**James City County Environmental Division
Stormwater Management/BMP Record Drawing &
Construction Certification Review
Tracking Form**

Project Name: Stonehouse PA1 Sec 7-A Richardson Mill Pond Sec 1
 County Plan No.: S-99-01 / S-100-02
 Stormwater Management Facility: BMP # 7.2 Timber Wall
 BMP Phase #: I II III
 Information Package Received. Date/By: June 13 2006 AES
 Completeness Check:
 Record Drawing Date/By: 6/13/06 AES
 Construction Certification Date/By: 4/22/06 GET
 RD/CC Standard Forms (Required for all BMPs after Feb 1st 2001 Only)
 Insp/Maint Agreement # / Date: 020022966, Oct 7 2002
 BMP Maintenance Plan Location: _____
 Other: _____
 Standard E&SC Note on Approved Plan Requiring RD/CC or County comment in plan review
 Yes No Location: Note to sheet 16
 Assign County BMP ID Code #: Code: WC077
 Preliminary Input/Log into Division's "As-Built Tracking Log"
 Add Location to GIS Map. Obtain basic site information (GPIN, Owner, Address, etc.)
 Preliminary Log into Access Database (BMP ID #, Plan No., GPIN, Project Name, etc.)
 Active Project File Review (correspondence, H&H, design computations, etc.)

BMP MODIFICATION PLAN
SECT. VII-A 'RICHARDSON'S MILL' SECT. 1
AT STONE

DESIGNED	DRAWN
VMB/RDS	AWT
Scale	Date
1"=50'	10/26/07
Project No.	
9028-08	
Drawing No.	
9

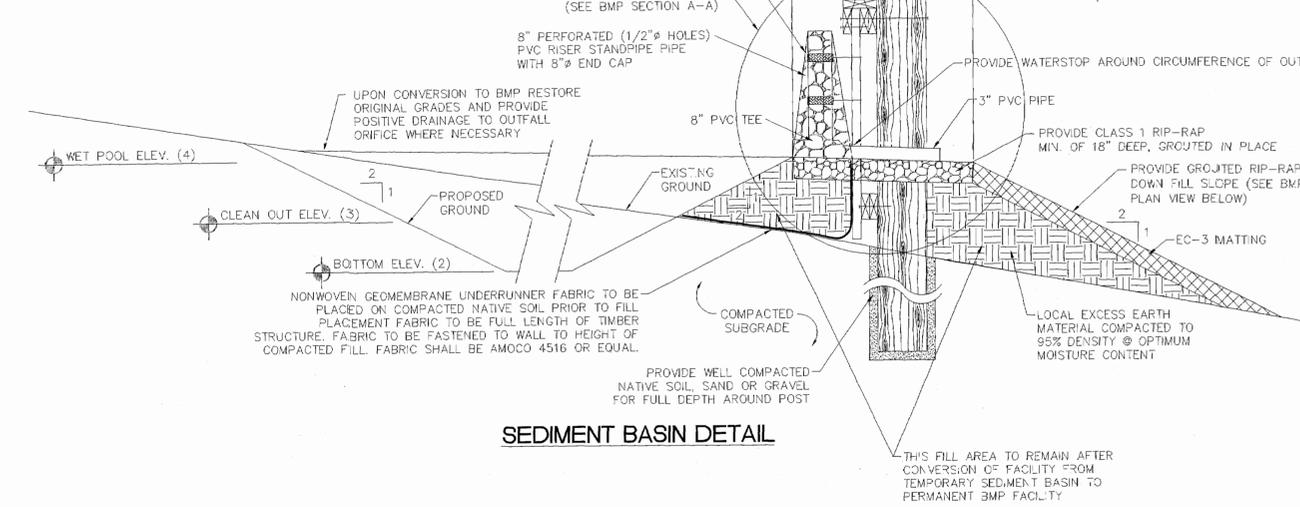
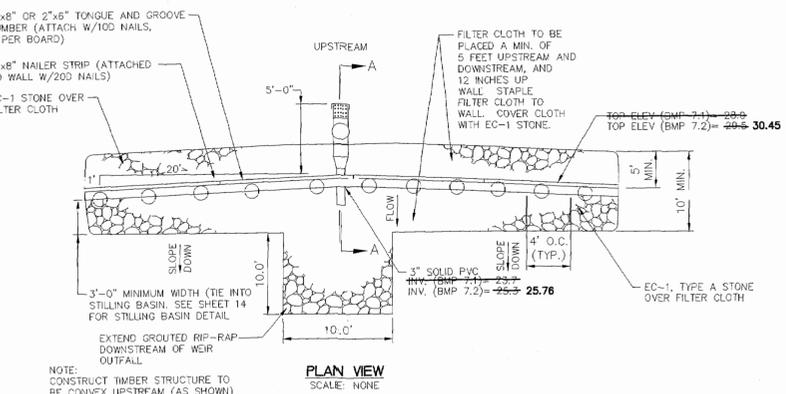
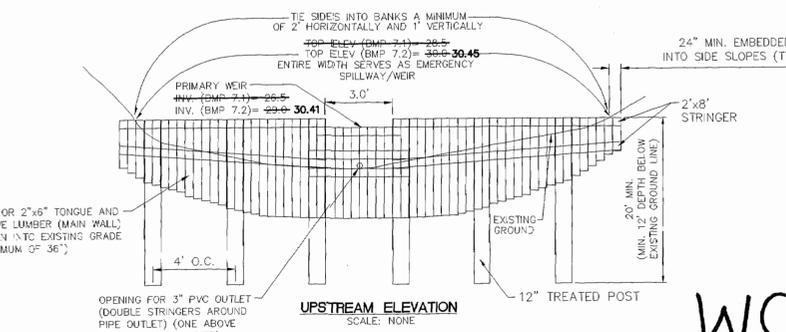
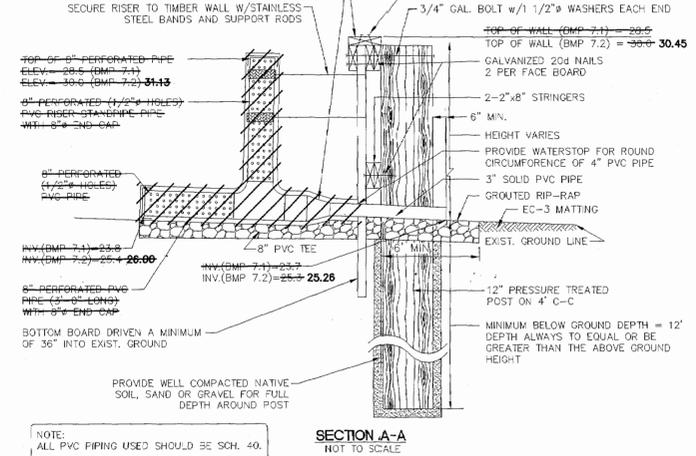
NO.	DATE	REVISION / COMMENT / NOTE
7	16/20/08	BMP CONVERSION
6	10/27/07	MODIFICATION TO PRIMARY SPILLWAY
5	10/27/07	RECORD DRAWING
4	10/25/07	NO REVISION THIS SHEET
3	10/25/07	NO REVISION THIS SHEET
2	7/26/07	NO REVISION THIS SHEET
1	5/14/07	NO REVISION THIS SHEET
NO.	DATE	REVISION / COMMENT / NOTE

DESIGNED: VMB/RDS
SCALE: NONE
DRAWN: AWT
DATE: 5/3/02
PROJECT NO.: 9028-8
DRAWING NO.: 14

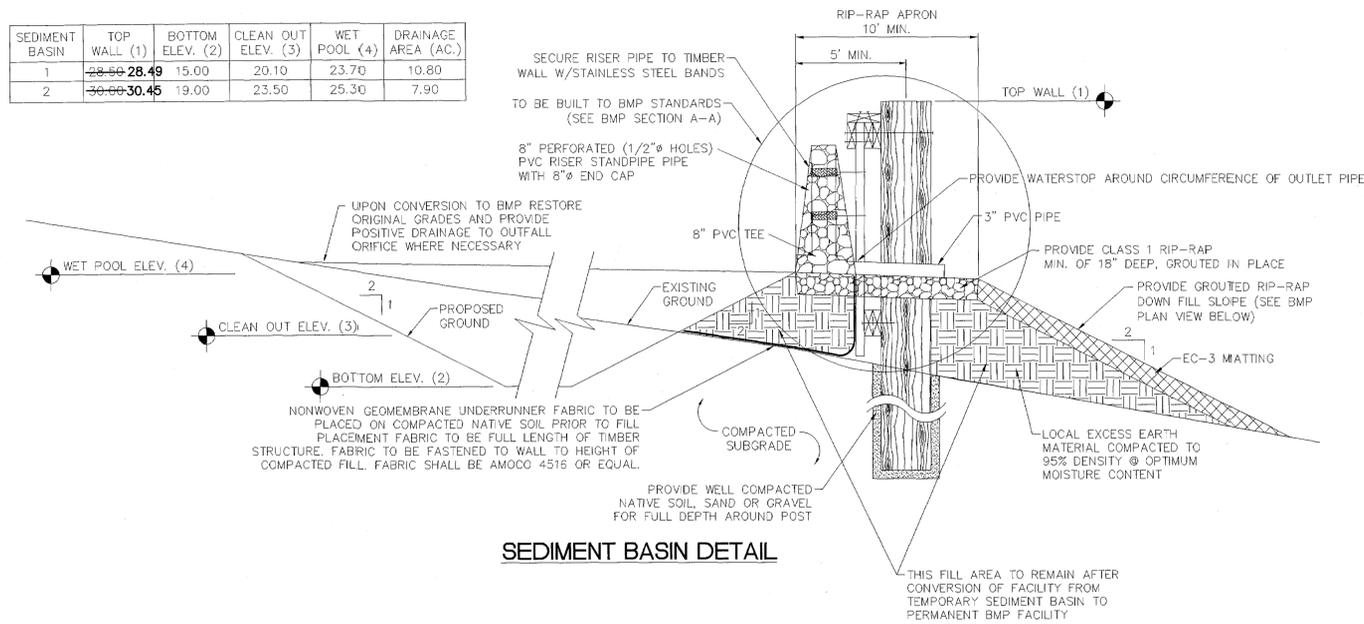
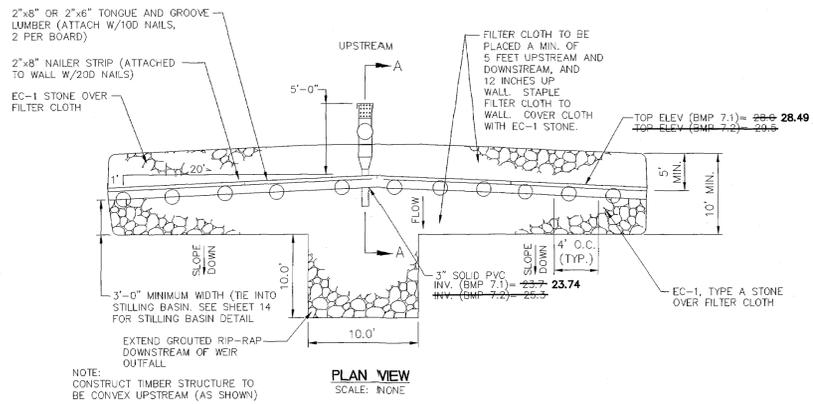
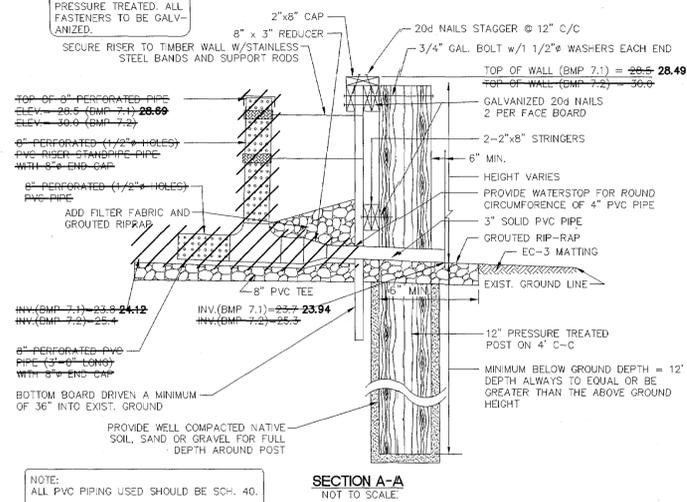
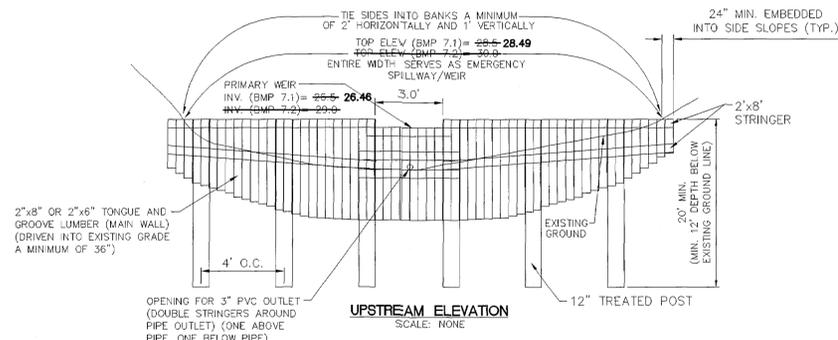
VAB	REVISION / COMMENT / NOTE	DATE	BY
7	BMP CONVERSION	6/20/08	
6	MODIFICATION TO PRIMARY SPILLWAY	10/29/07	
5	RECORD DRAWING	8/16/04	
4	NO REVISION THIS SHEET	10/28/02	
3	REVISED PER JCC COMMENTS DATED 9/26/02	9/20/02	
2	REVISED PER JCC COMMENTS DATED 8/20/02	7/26/02	
1	SHEET ADDED	8/14/02

NOTE: CONSTRUCT TIMBER STRUCTURE TO BE CONVEX UPSTREAM (AS SHOWN)
